Appendix 1: Additional information required for proposed PRCP schedule

Provide a revised PRC plan (including PRCP schedule) that addresses the following matters:

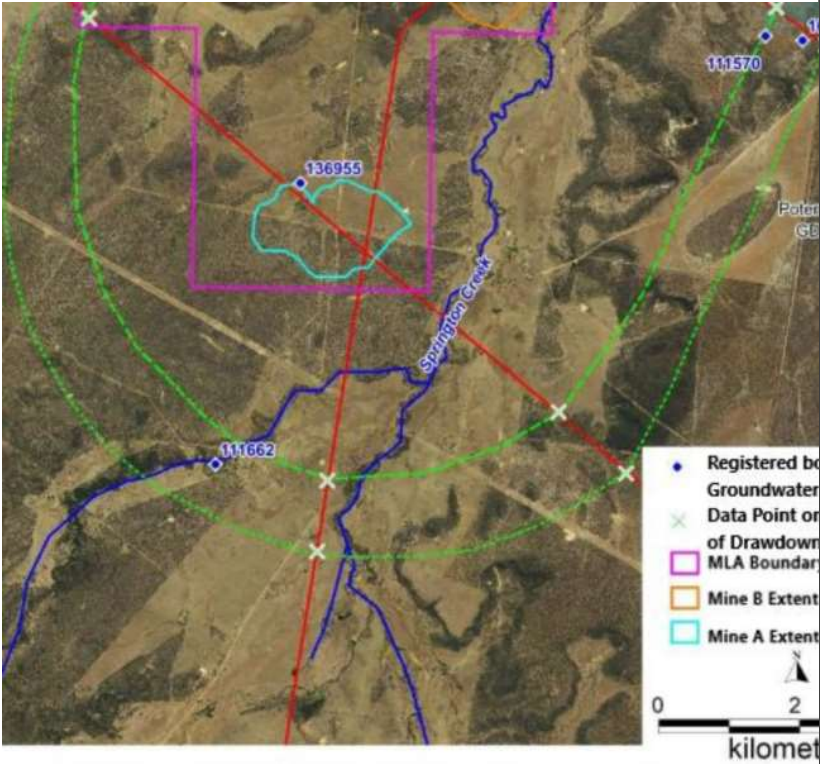
13.	3.3.3 Proposed post-mining land uses 3.5.6.7 Final void study	Final voids PMLU Magnetic South have made a commitment to rehabilitate the final voids to achieve a PMLU of fauna habitat. While this may be achievable in the first 100 years, there is risk associated with the increasing salinity levels and their ability to support an aquatic ecosystem over the long-term. Figure 52 (section 3.5.6.7) shows that the salinity levels are predicted to continue to increase over 500 years for Mine A void. A PMLU must be able to achieve a stable condition, which in accordance with s111A of the EP Act: Land is in a stable condition if – a) The land is safe and structurally stable, and b) There is no environmental harm being caused by anything on or in the land, and c) The land can sustain a PMLU. The requirement for land to sustain a PMLU, and prevent environmental harm, does not end after 100 years. The PRC plan must demonstrate how the final voids will achieve fauna habitat, particularly the aquatic ecosystem component, to reach a stable condition post-closure. The PRCP Schedule must include appropriate SMART criteria that will achieve and sustain the PMLU. As per section 3.2 of the PRCP guideline, it is the applicant's responsibility to provide sufficient evidence and justification regarding any proposed PMLU.	1. Update the PRCP Plan to explain how the final voids will reach a stable condition, and continue to sustain an aquatic ecosystem long-term. 2. Ensure criteria that meet the SMART principle are included in the schedule that will deliver a stable PMLU of fauna habitat.	Modelled salinity of the residual void lakes suggests that they would be unable to support an aquatic ecosystem long-term. Based on this conclusion, DETSI has approved for residual void lakes to be classified as NUMAs. Further information can be found in section 3.4 of the Gemini PRCP supporting information.

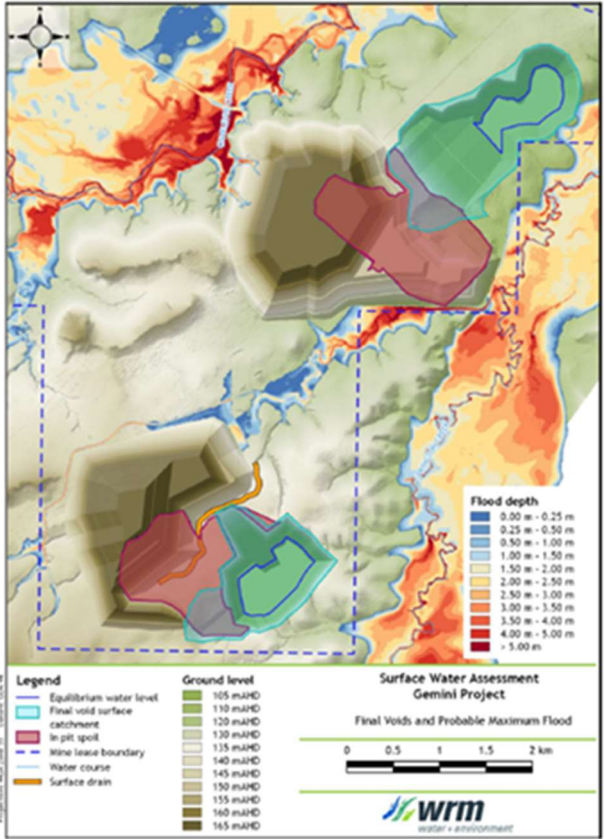
22.	3.5.6.3 Landform design	Erosion assessment Erosion assessment discussed in Section 3.5.6.3 has not been provided in full. The details of the erosion assessment undertaken are essential for understanding the modelling used to underpin any conclusions drawn in the PRC plan and understanding any risks to the final landform. It is also essential in developing the milestone criteria for the Schedule as it relates to erosion.	1. Provide the erosion assessment/WEPP modelling report in full as an appendix to the PRC Plan.	Gemini Coal Mine Erosion Stability Assessment has been attached to the PRCP as Appendix J.
